**Addendum No. 1**

**PROJECT:** Lupton City Mill Sewer Relocation

**Project No.:** 37001-00

**ISSUED DATE:** December 2, 2019

Approximate location of on-site disposal area for unsuitable fill

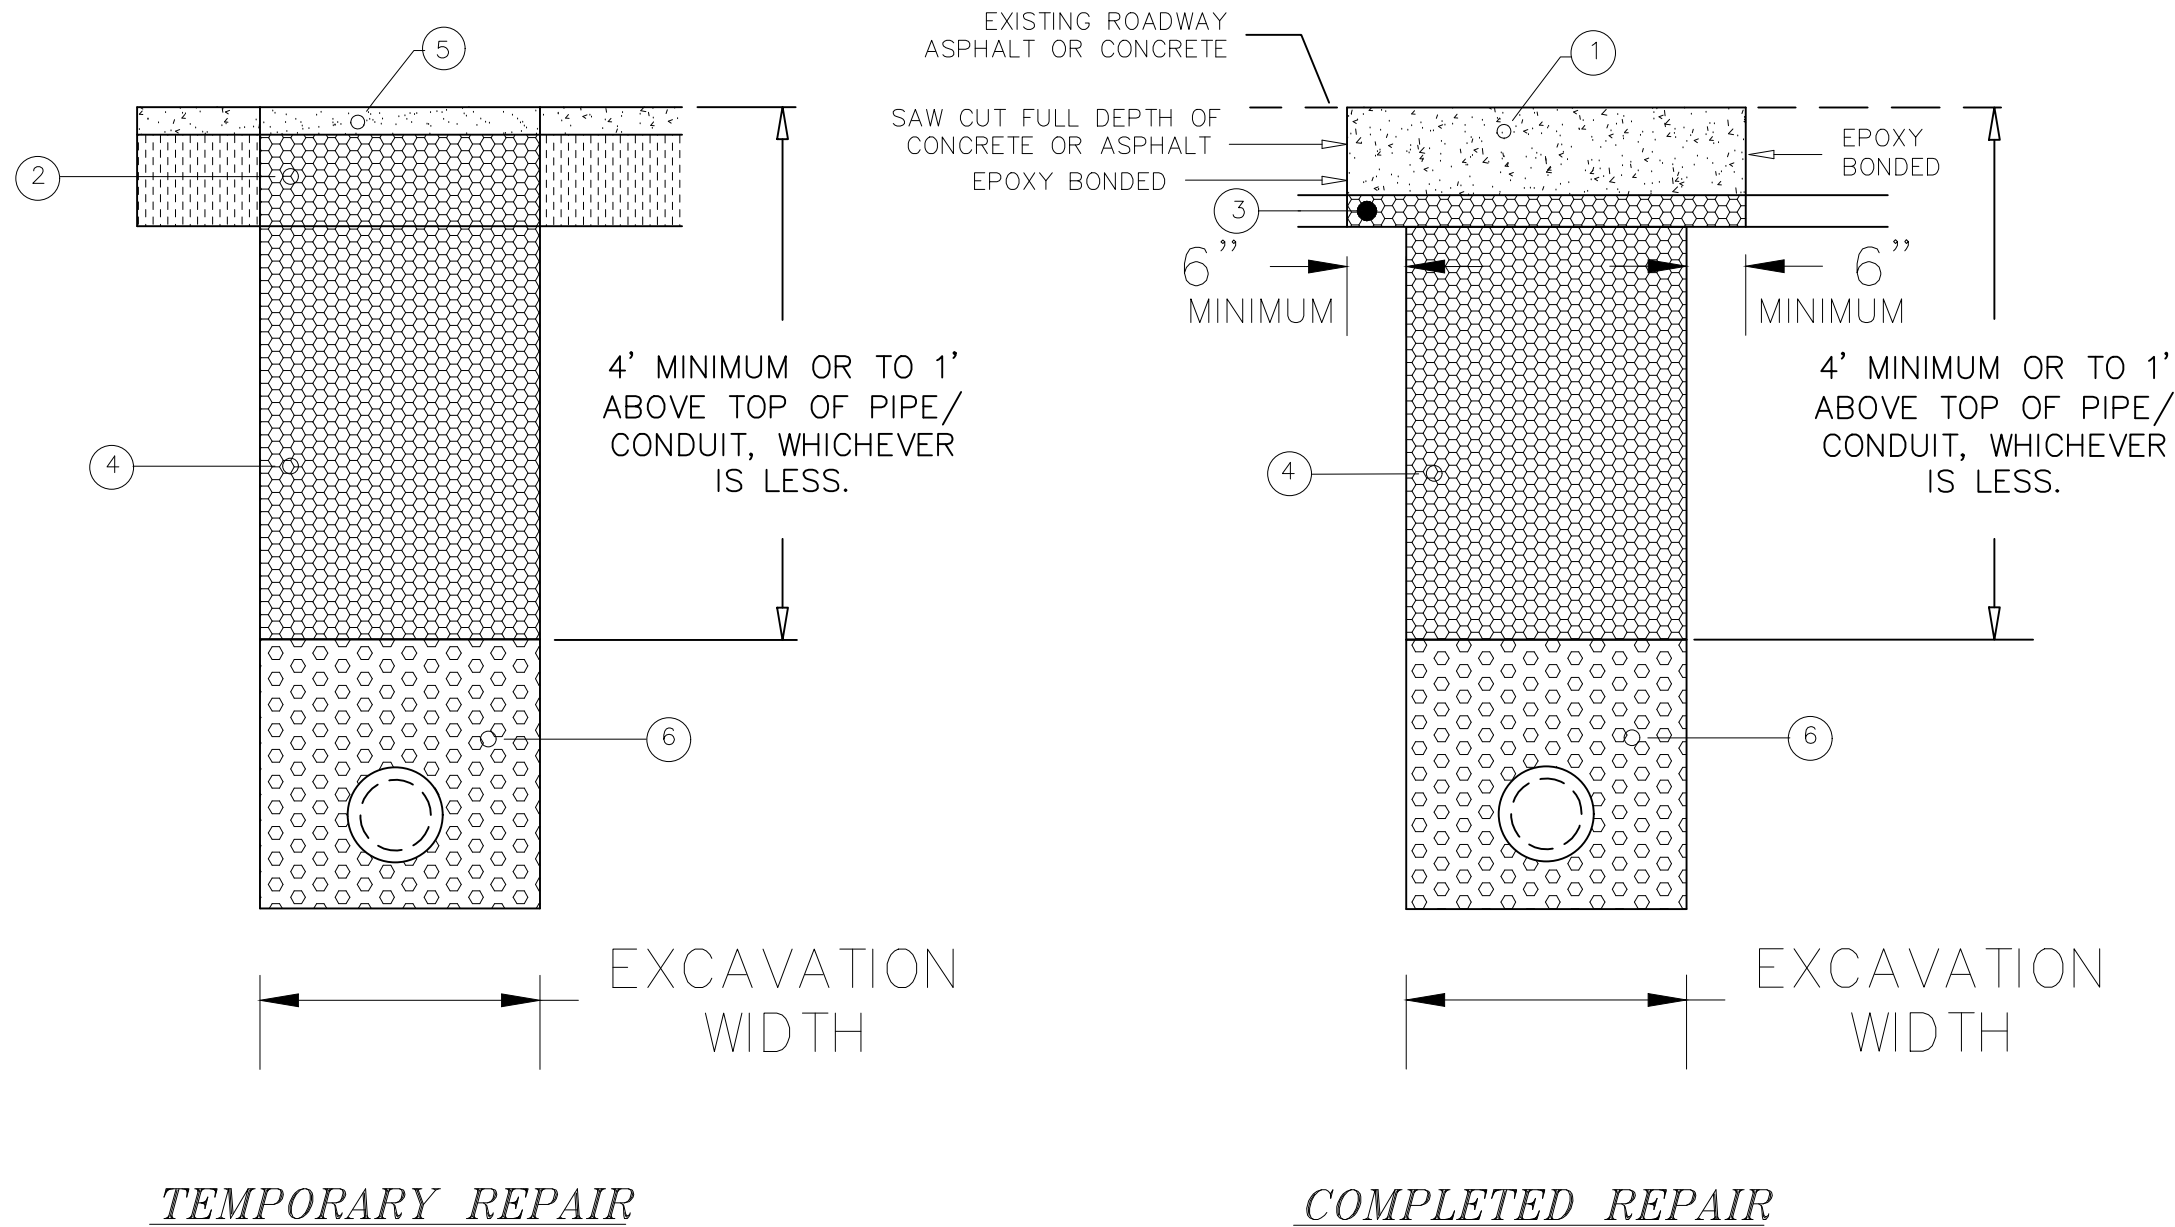
**Response:** See newly added Sheet C7.03.
5. **Question:** There is a bid item for "On-Site Disposal"... Where is this area located?  
**Response:** On-Site Disposal will be on the Lupton City Mill site. See Attachment 1 for approximate location.

- Attachment 1 indicates the on-site disposal area and is attached for Bidder reference.
- Drawing C7.03 has been added to include City of Chattanooga pavement repair detail.
- Drawing G0.01 has been revised to include Drawing C7.03.
- Revised Specification 00 41 00 "Bid Form"
- Revised Specification 01 22 00 "Measurement and Payment"
- Pre-bid meeting notes and sign in sheet.

1 REPAIR DETAILS (ROADWAY) SD-700.01  
C7.03 SCALE: NTS

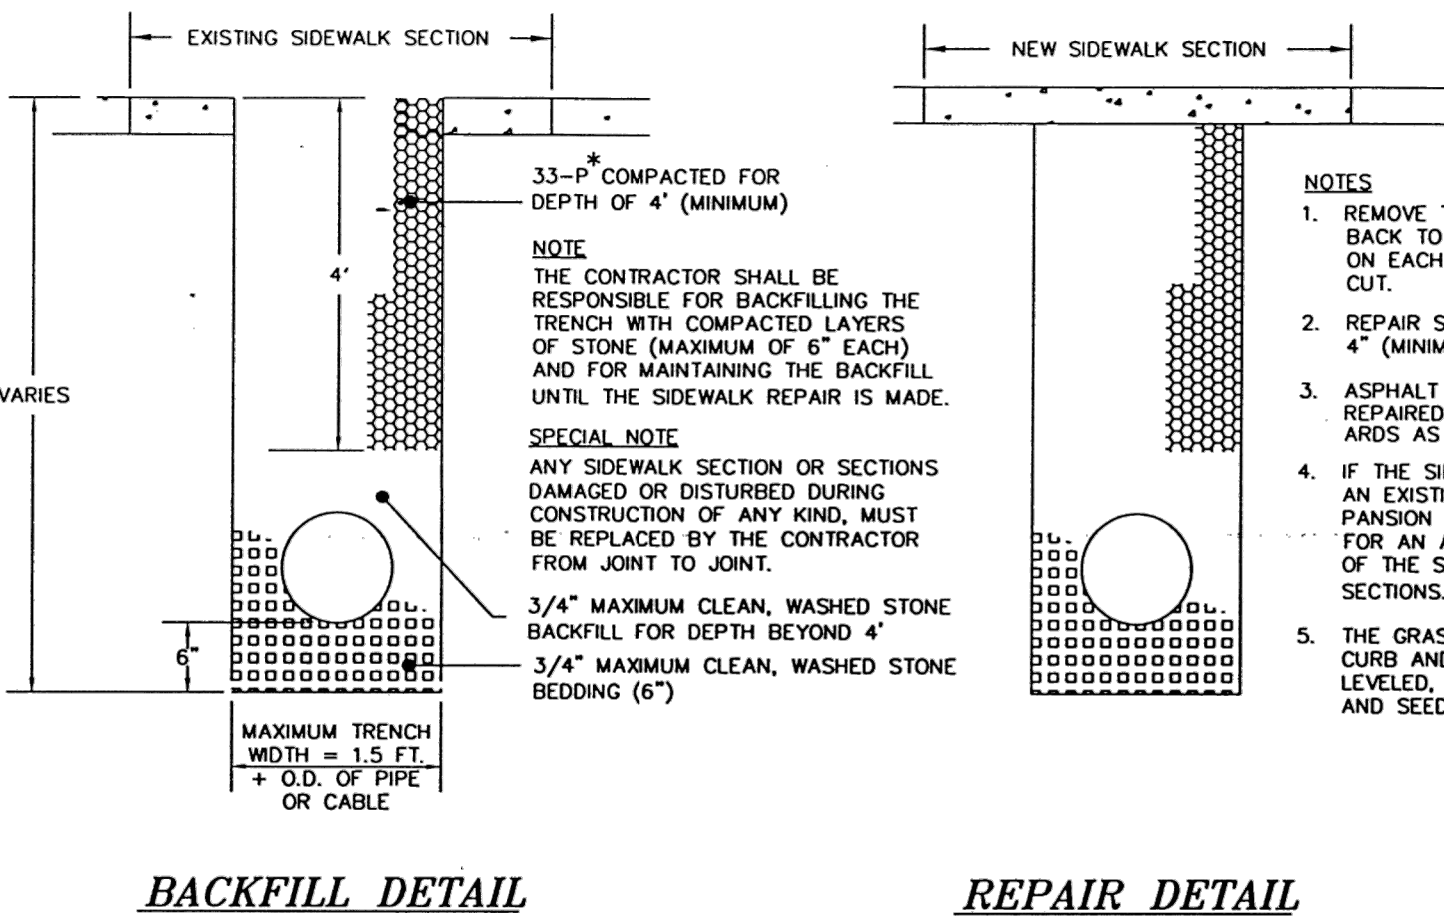
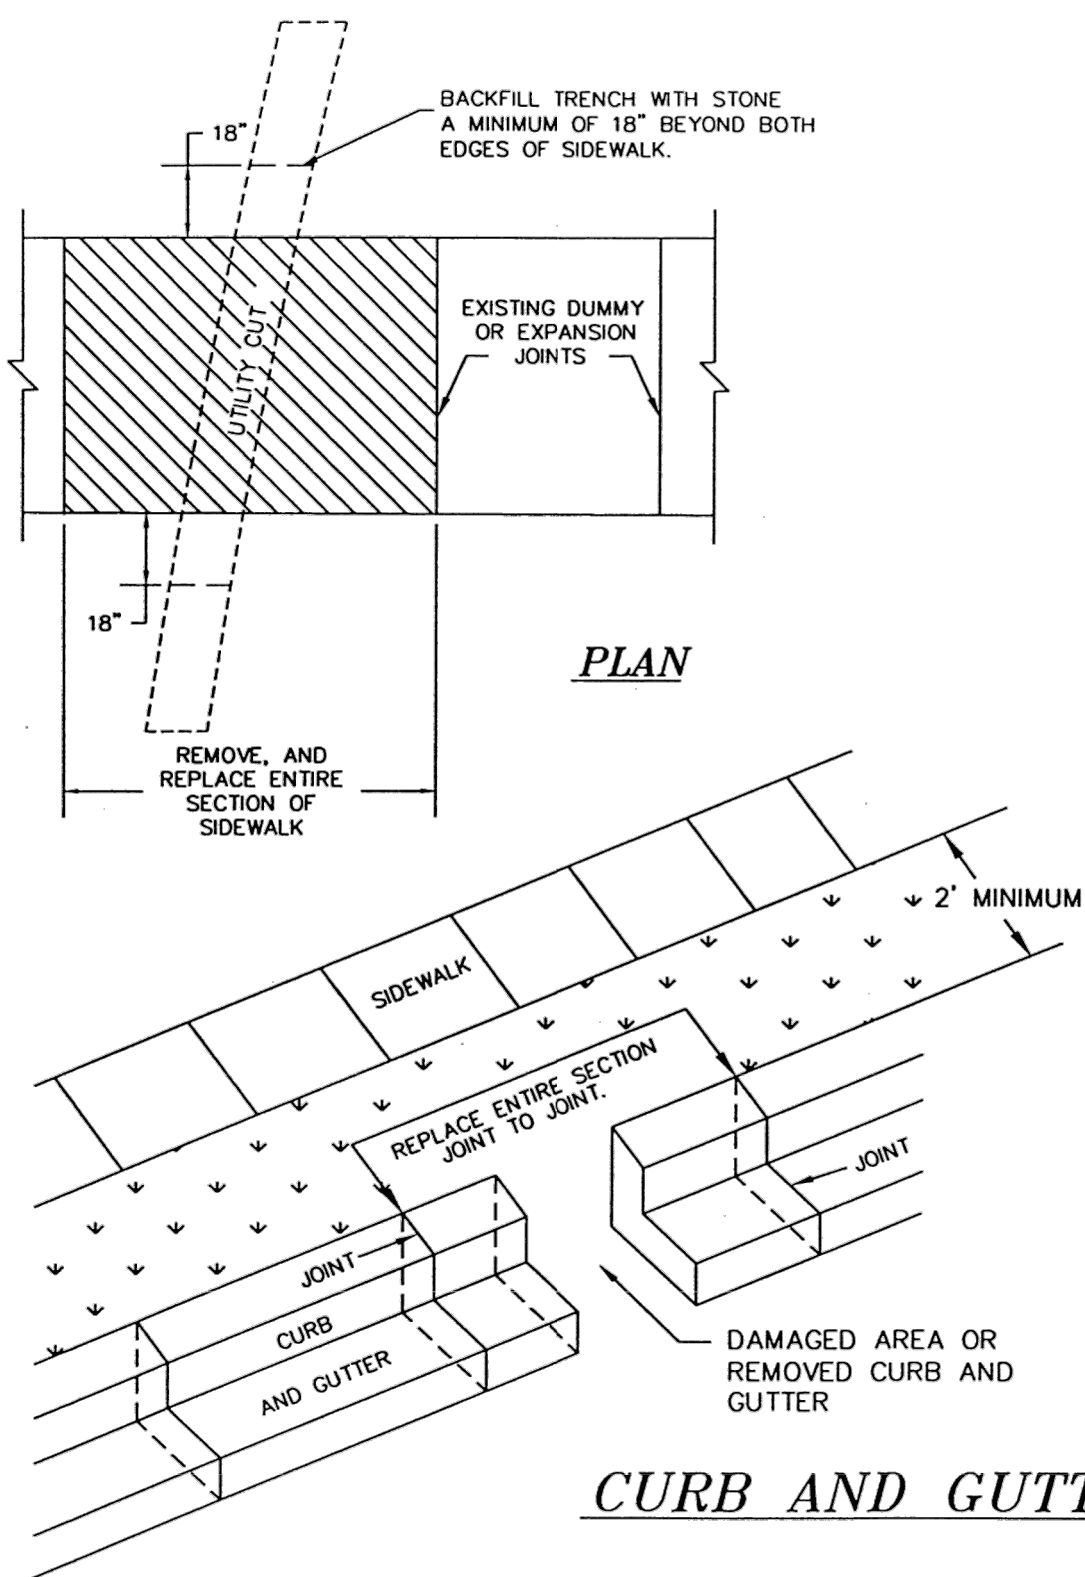
4. **Question:** The plans show "Pavement Restoration" need to complete the desired scope of work. Can a detail be provided showing the base and binder thickness?

1. Refer to Drawing C7.03 – Sheet added to include City of Chattanooga pavement repair detail.
2. Refer to Drawing G0.01 “Cover Sheet” – Cover sheet has been revised to include Drawing C7.03.
